WHC-MR-0289
Revision 3

Documentation of Hanford Site Independent Review of the Hanford Waste Vitrification Plant Preliminary Safety Analysis Report

**DOCUMENTATION OF HANFORD SITE INDEPENDENT REVIEW
OF THE HANFORD WASTE VITRIFICATION PLANT
PRELIMINARY SAFETY ANALYSIS REPORT**

TYPICAL CLOSED LOOP ARRANGEMENT

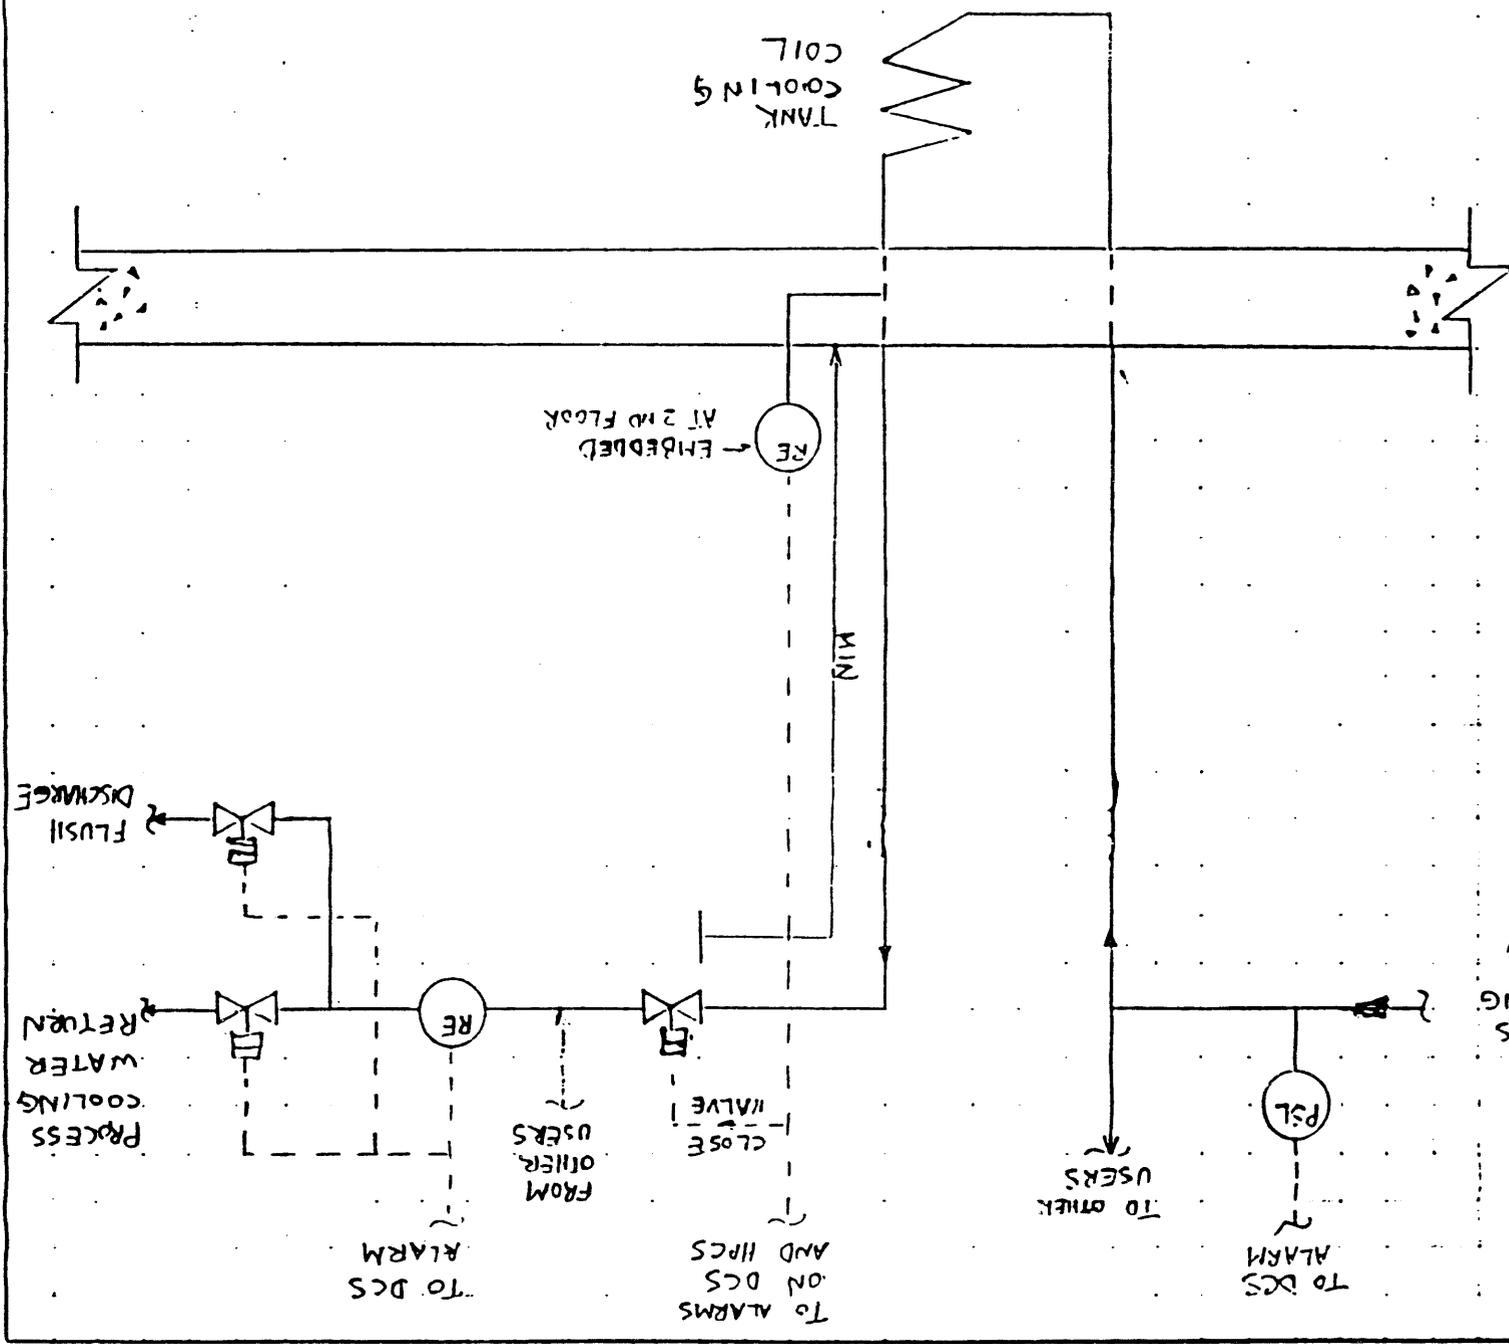
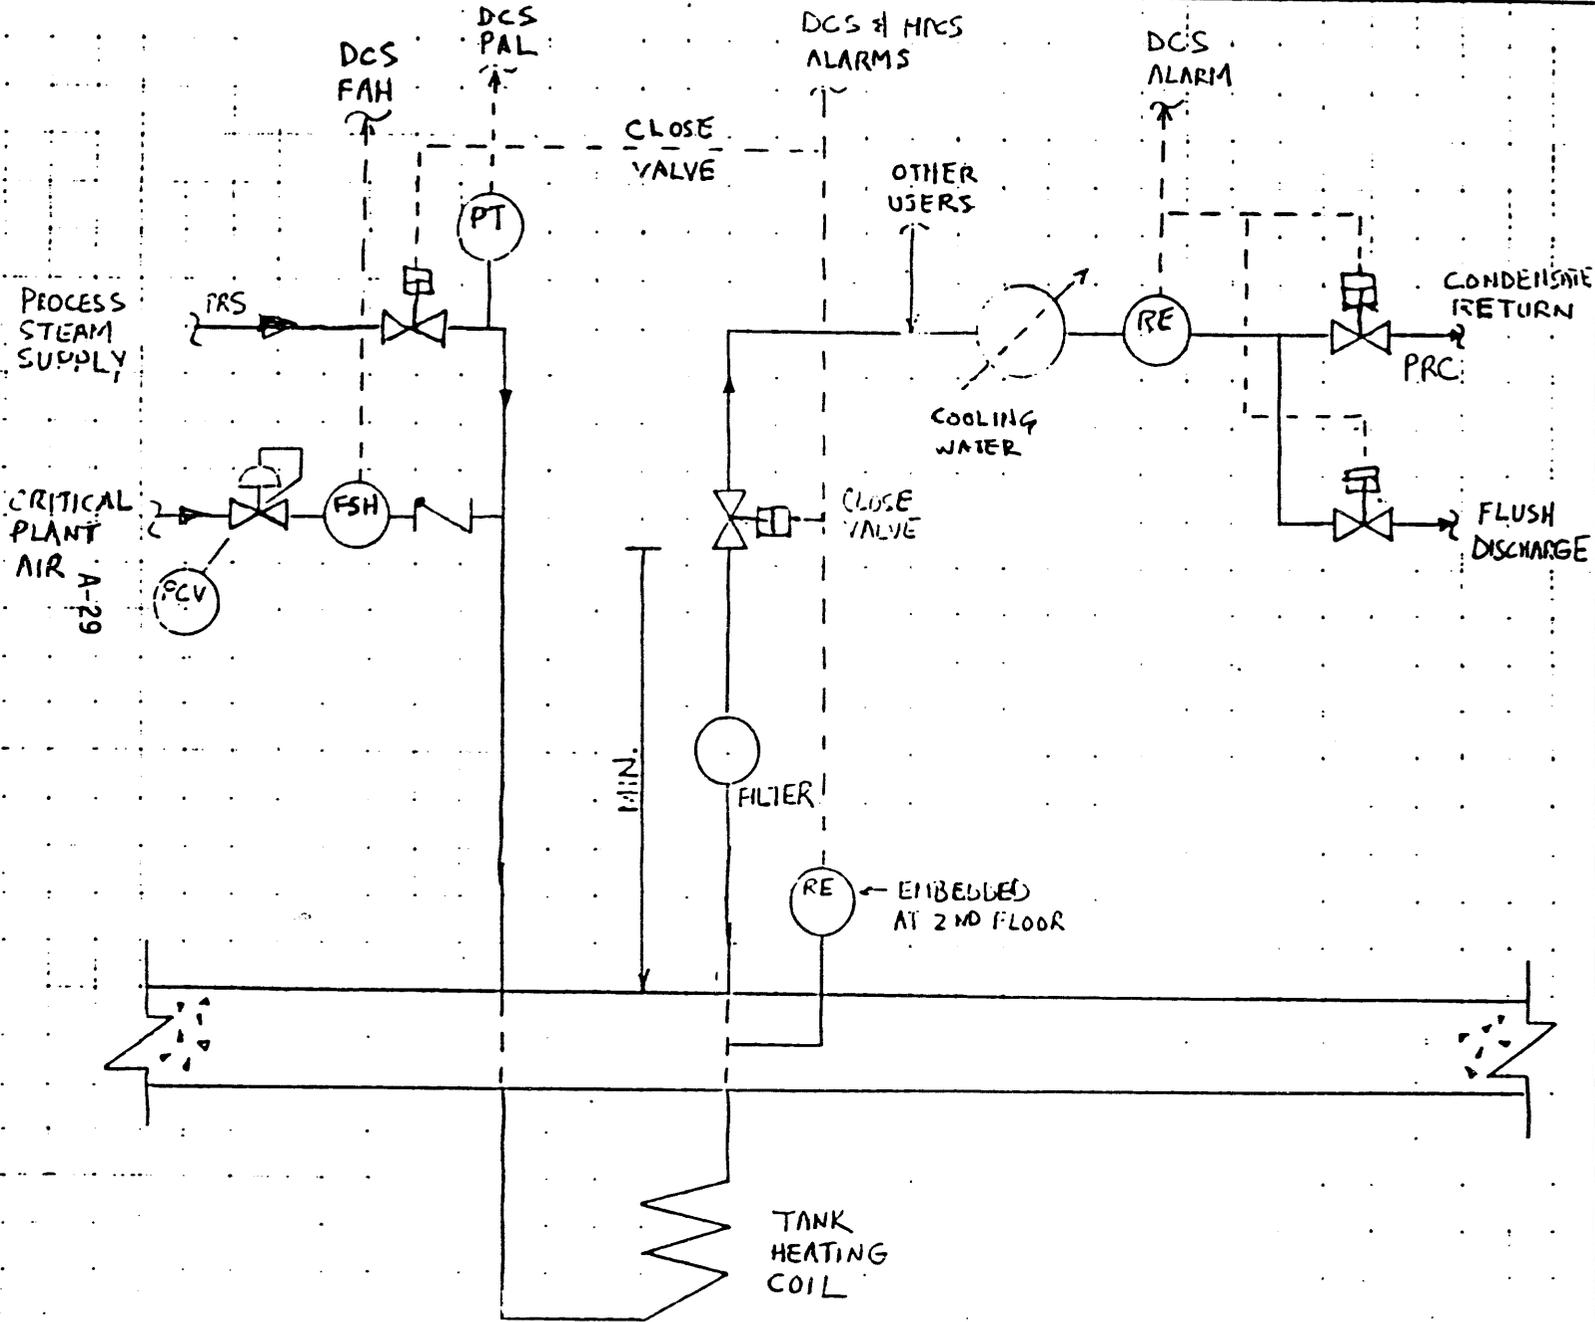
4. The designs of the closed loop process cooling water and steam/condensate systems were questioned from the point of view of adequately precluding leaks that could contaminate the Vitrification Building and ultimately result in worker exposures. It was asserted that it will not be possible to achieve the design leakage paths under all credible failure potentials, and that there is a high probability that the leak detection and isolation features will not be effective.

- **Action:** The HWVP project will make presentations on these systems and will either demonstrate that the current design will perform satisfactorily from a safety perspective, or the project will establish a commitment that is acceptable to the Subcouncil.
5. The orientation of the Railroad Well with respect to the Vitrification Building was questioned with regard to the possibility of a train crash. The HWVP project stated that the design is the same as DWPF's, and that the crash probability is reduced to an acceptable level by switches and use of "donkey" train.

HWVP CONCERNS

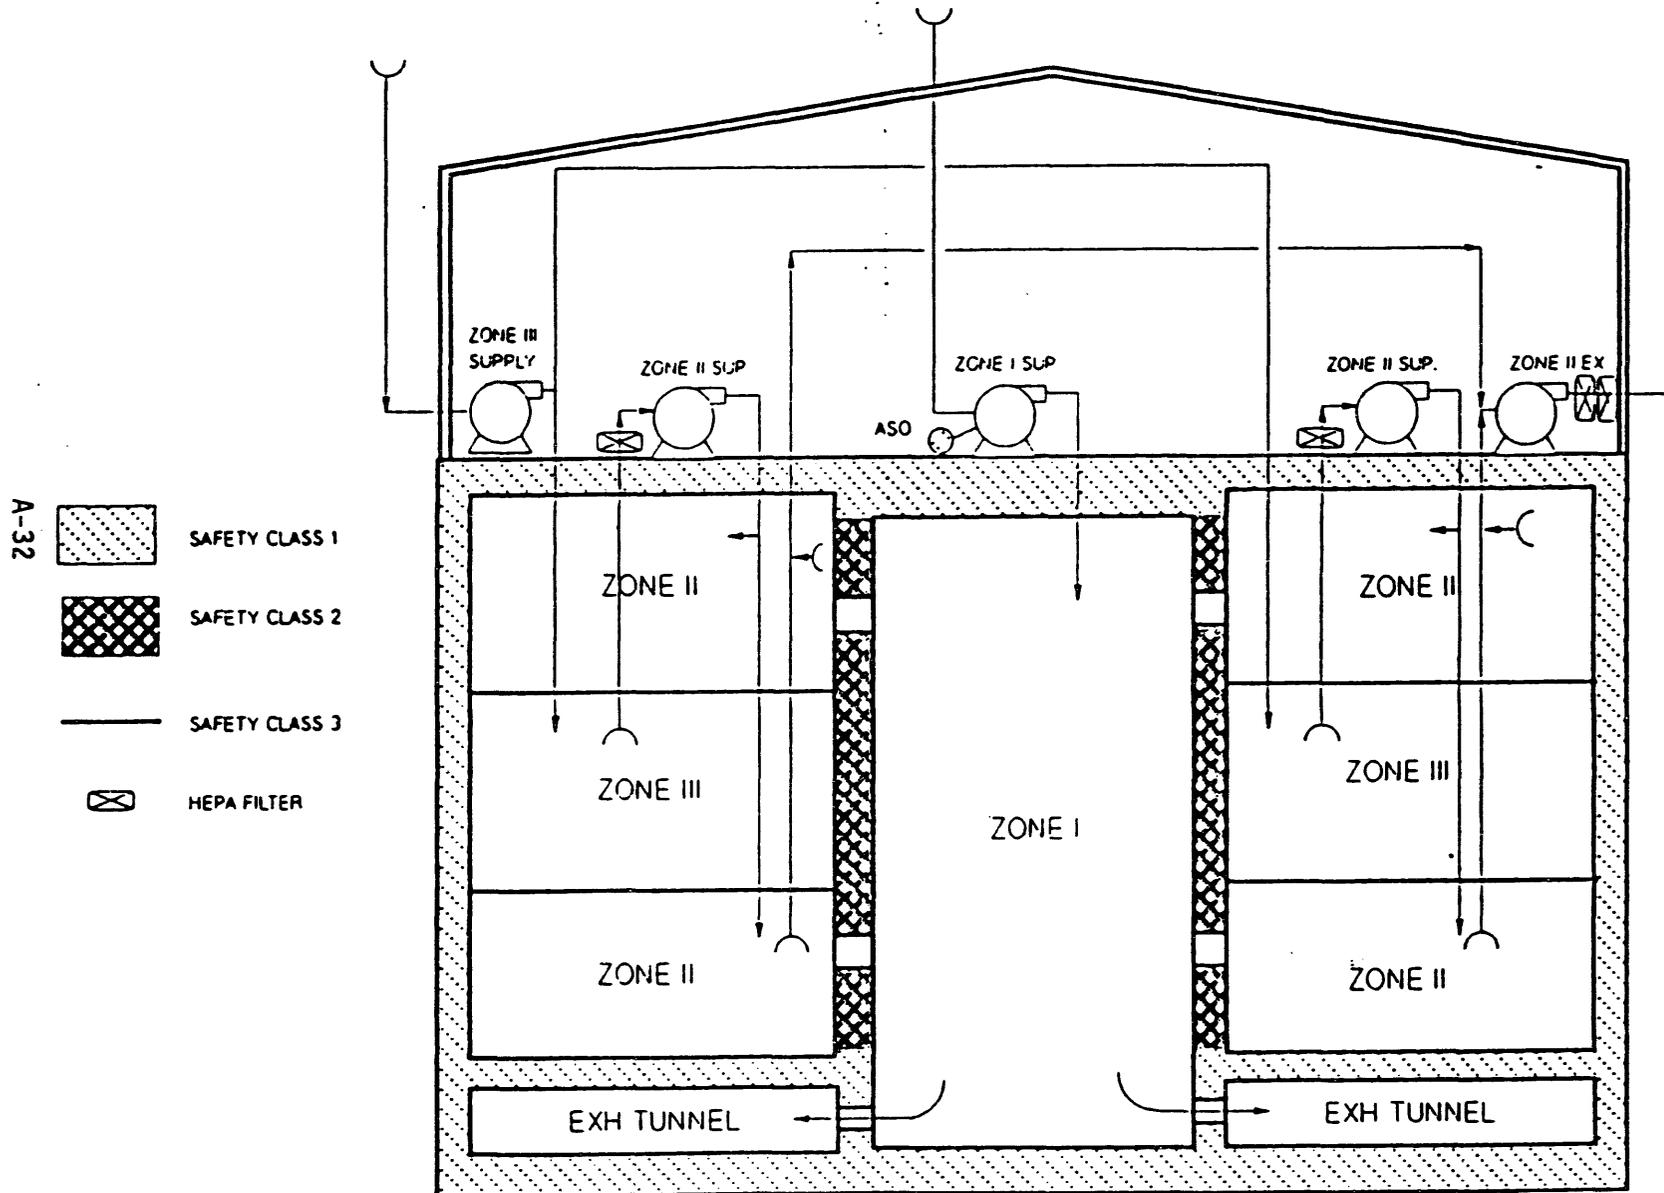
- DOES NOT MEET THE REQUIREMENT THAT AT LEAST ONE CONFINEMENT BOUNDARY AND IT'S VENTILATION SYSTEM BE SAFETY CLASS 1.
(6430.1A; 1300-7.2)
- IF SAFETY CLASS 2 CELL PENETRATION FAILS AND ZONE II EXHAUST CONTINUES TO RUN, CONCEIVABLY CELL ATMOSPHERE COULD BE EXHAUSTED THROUGH ZONE II (NON SAFETY CLASS SYSTEM).
- IF ZONE III EXHAUST FAILS BUT SUPPLY CONTINUES TO RUN THE SAFETY CLASS 1 BOUNDARY COULD BE PRESSURIZED.
